APPEAL SUMMARY

Appeal ID: 20546	Project Address: 1600 SW Salmon St
Hearing Date: 6/19/19	Appellant Name: Tom Jaleski
Case No.: B-017	Appellant Phone: 503.488.5651
Appeal Type: Building	Plans Examiner/Inspector: Jody Orrison
Project Type: commercial	Stories: 6 Occupancy: A-2, A-3, B, E, S-1 Construction Type: I-B
Building/Business Name: Lincoln High School	Fire Sprinklers: Yes - Throughout
Appeal Involves: Erection of a new structure	LUR or Permit Application No.:
Plan Submitted Option: pdf [File 1] [File 2]	Proposed use: High School - Main Building

APPEAL INFORMATION SHEET

LINCOLN HIGH SCHOOL REPLACEMENT

12 ENLARGED STAIR 1 PLAN - LEVELS 3-6
1/4" = 1'-0"

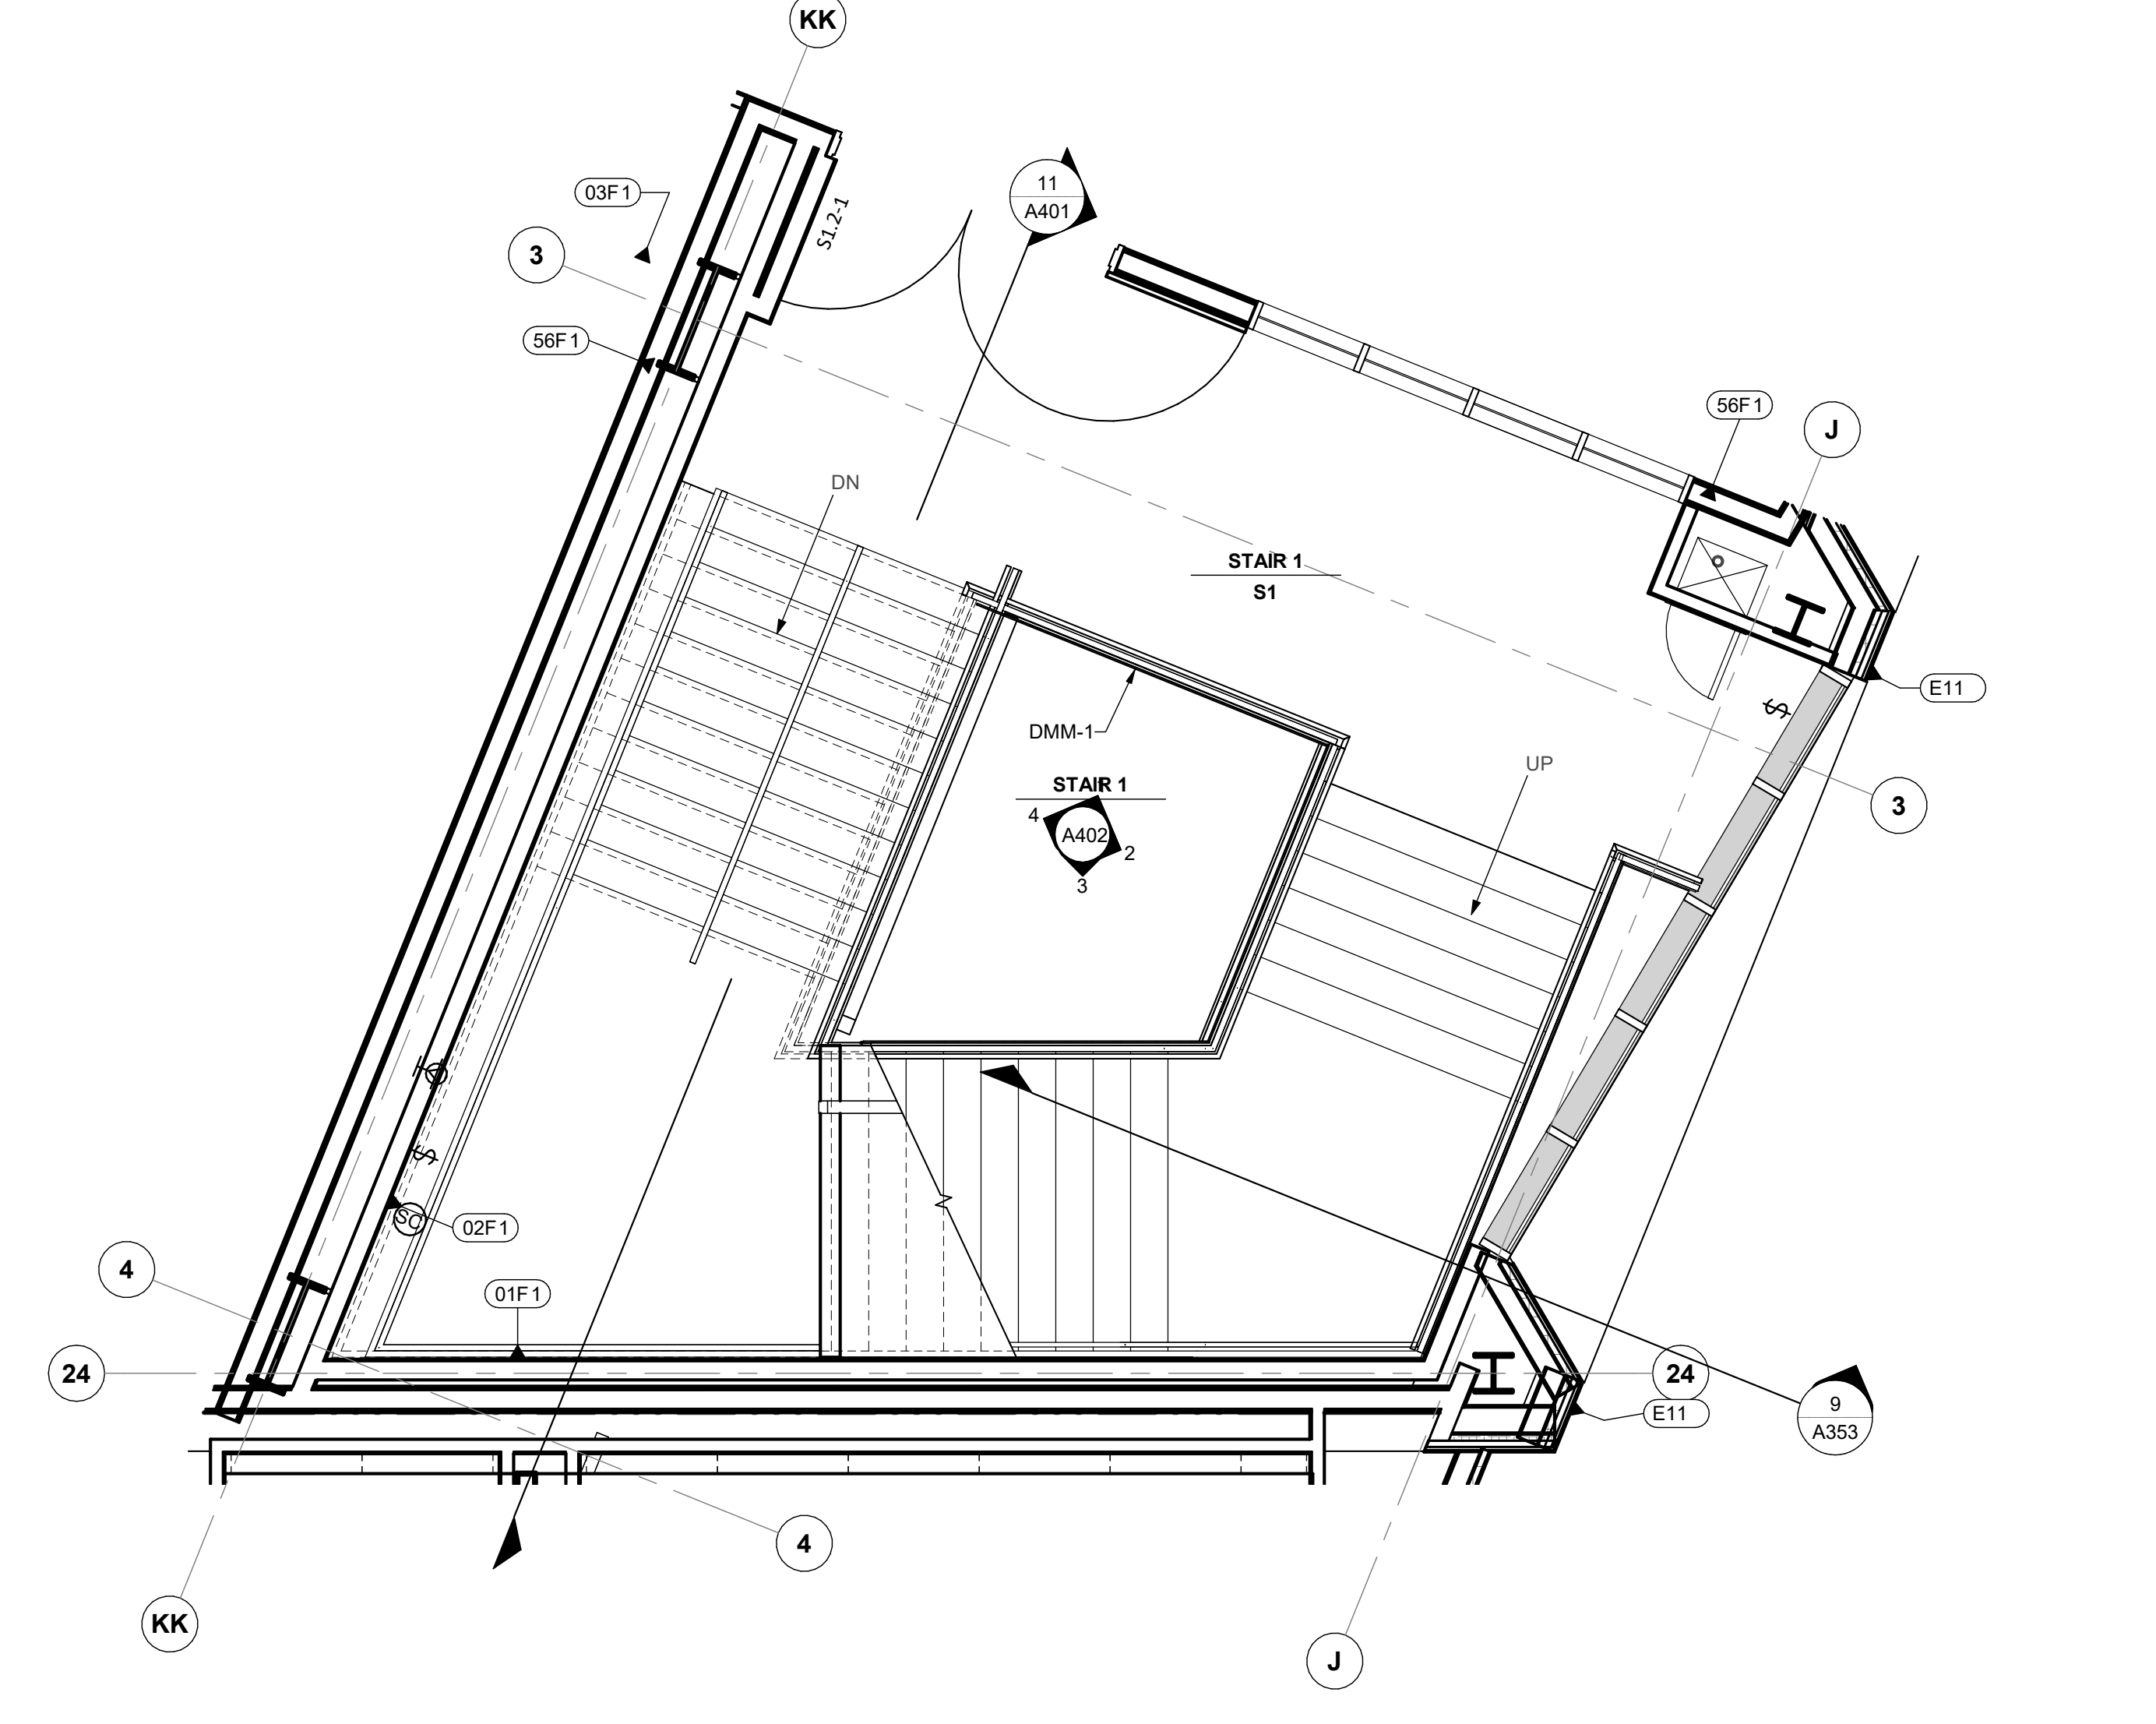
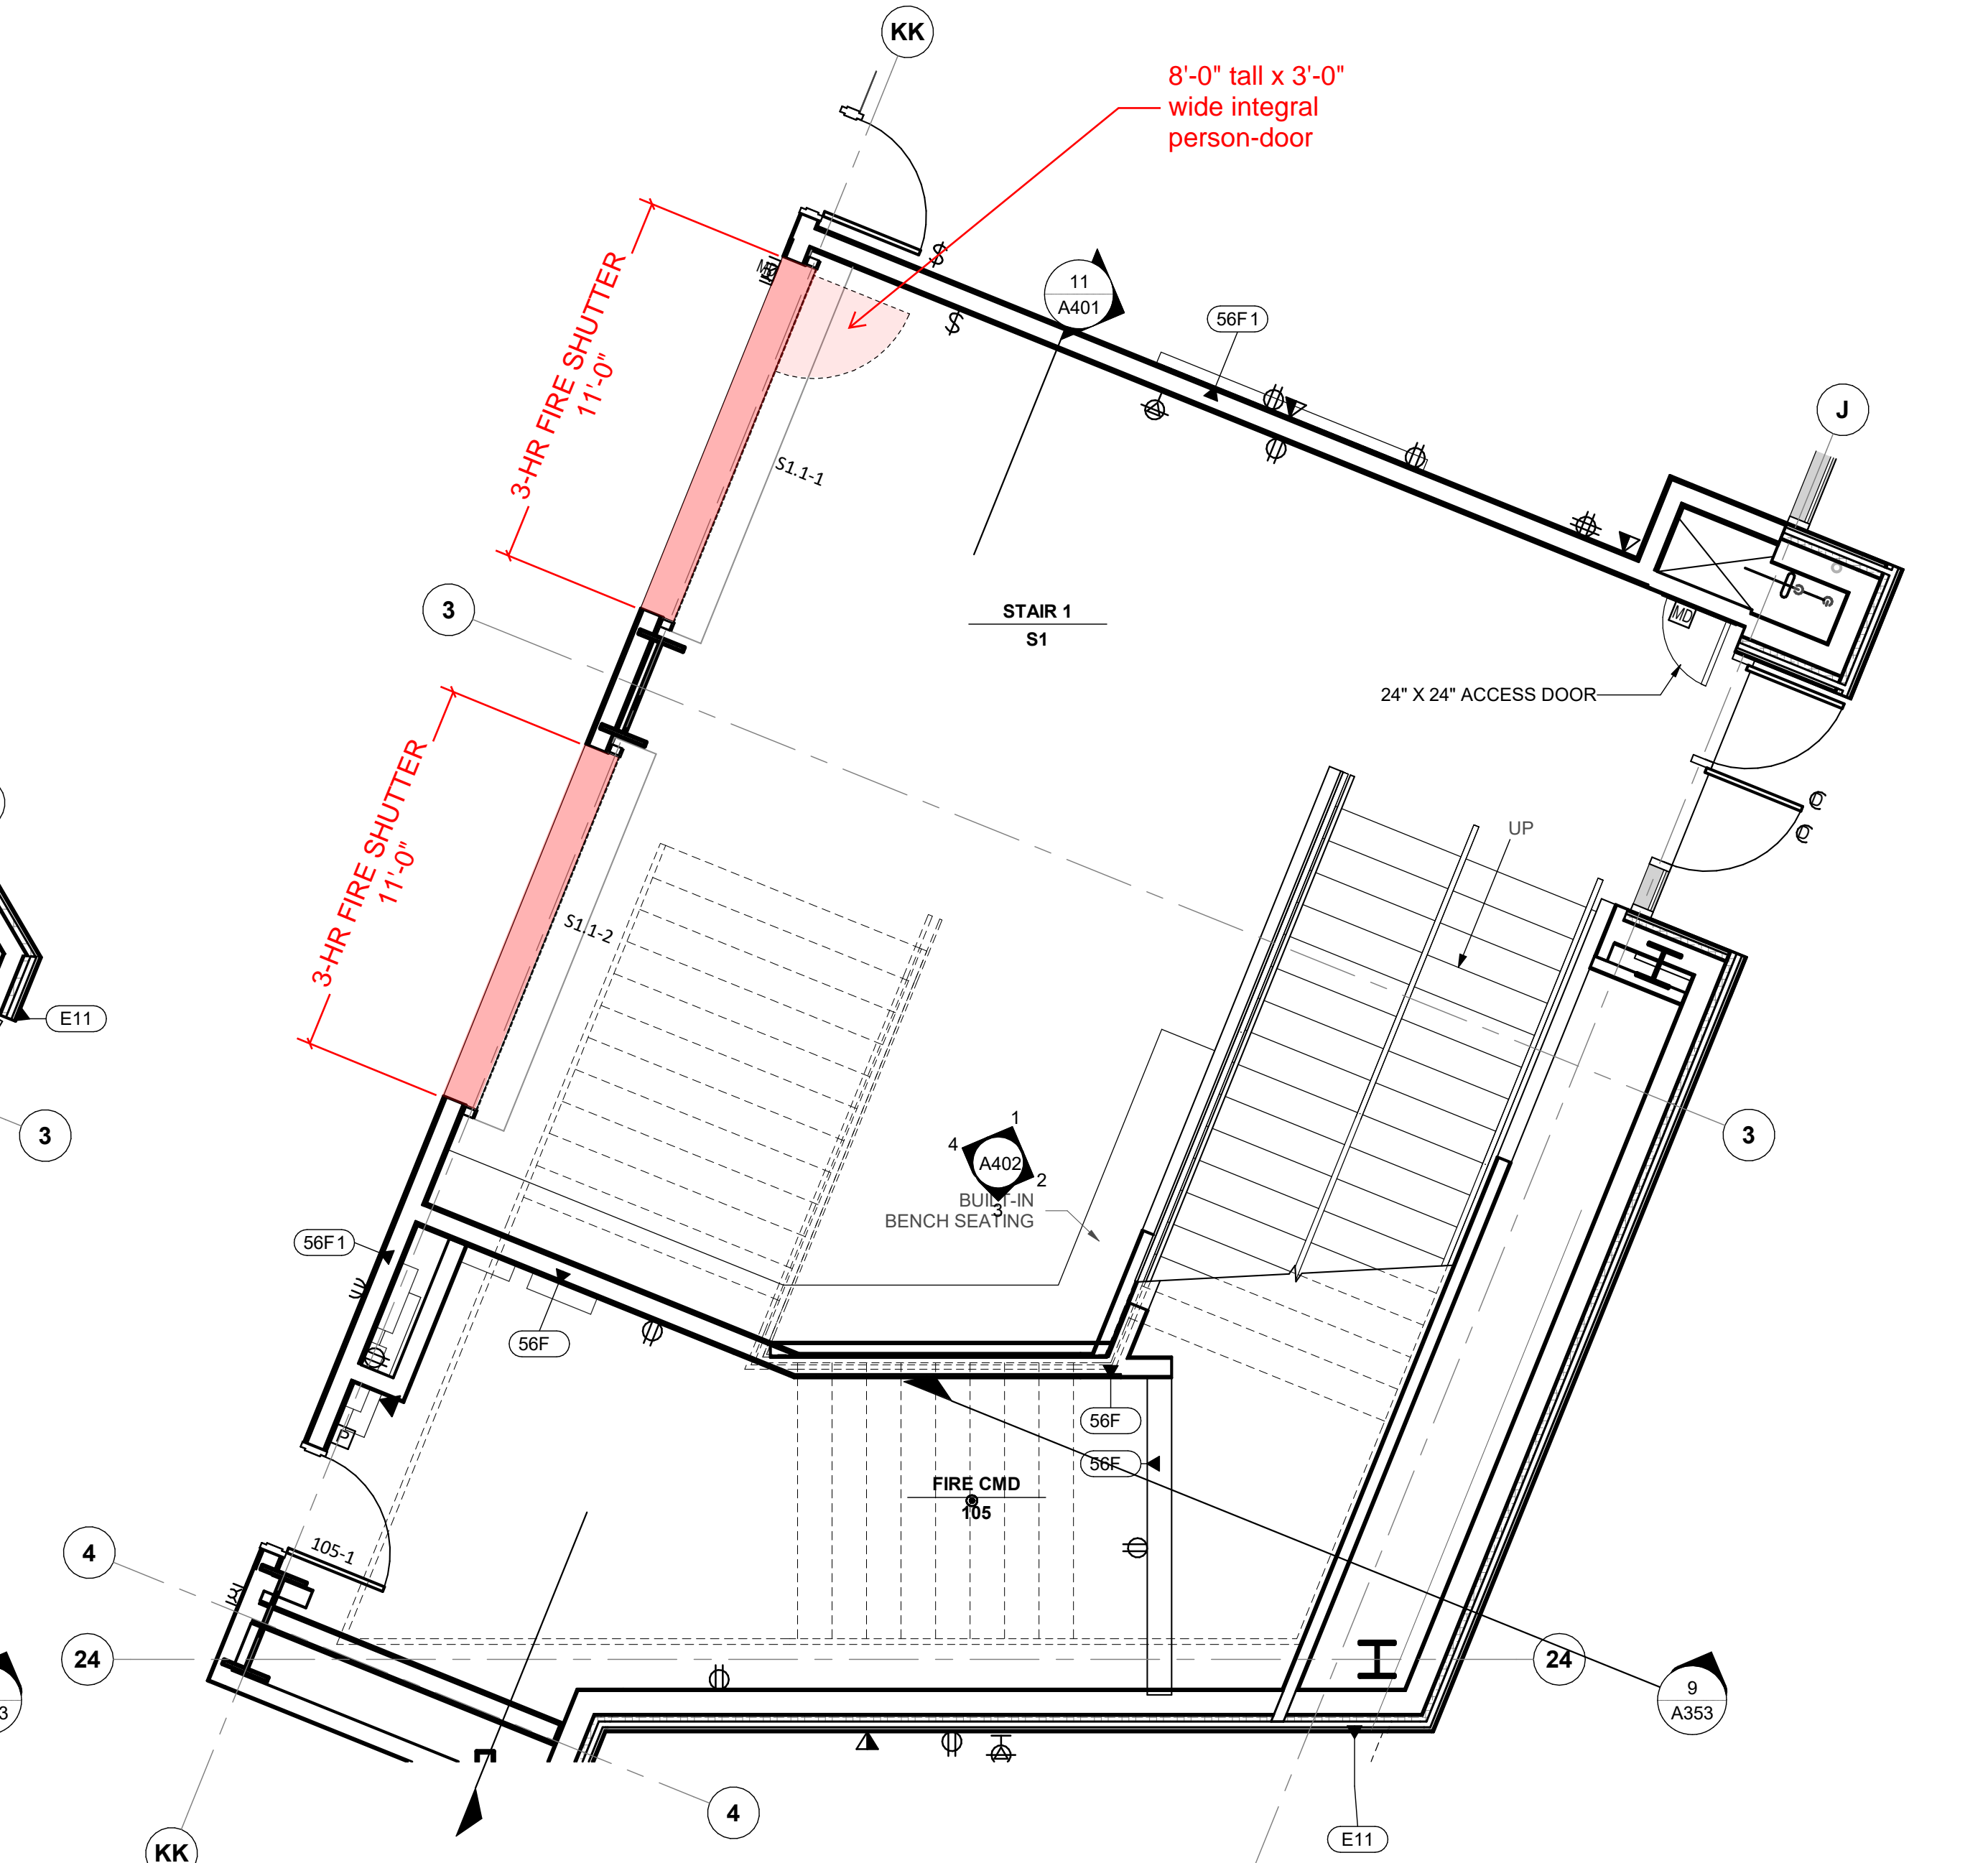
Stair 1:

- CONDITION: Six-story interior exit stairway.
- RATING: 2-hour fire-resistance-rated enclosure.
- EGRESS: Two (2) egress doors from enclosure direct to the exterior.

- o Two openings located on west wall of enclosure at Level 01.
- o Each protected with a 3-hour fire shutter meeting UL 10B (equivalent) and UL 1784, and provided with an automatic-closing device and smoke detection.
- o Both shutters are 11-ft wide by 12-ft tall (132 sf).
- o One of the shutters will include a 3-ft wide by 8-ft tall integral person door.

2b. The 3-hour fire-resistance-rated fire shutters located on the west wall of the Stair 4 enclosure and on the west wall of the Stair 1 are not prescriptively allowed. The shutters will provide equivalent fire life safety as compared to the code requirements of a stairway enclosure in a fire event by meeting, and in some requirements exceeding, the opening protective provisions of Chapter 7 as follows:

Therefore, due to equivalent life safety protection being provided to meet the intent of §1009.3.1.4.1 and §1022.4, it is requested that the two (2) openings in Stair 1 and the two (2) openings in Stair 4 be permitted when protected with a 3-hour fire-resistance-rated fire shutter or 2-hour fire glass as identified in the proposed design.

2. Openings in (2) two hour fire rated stair enclosures: Hold for additional information.
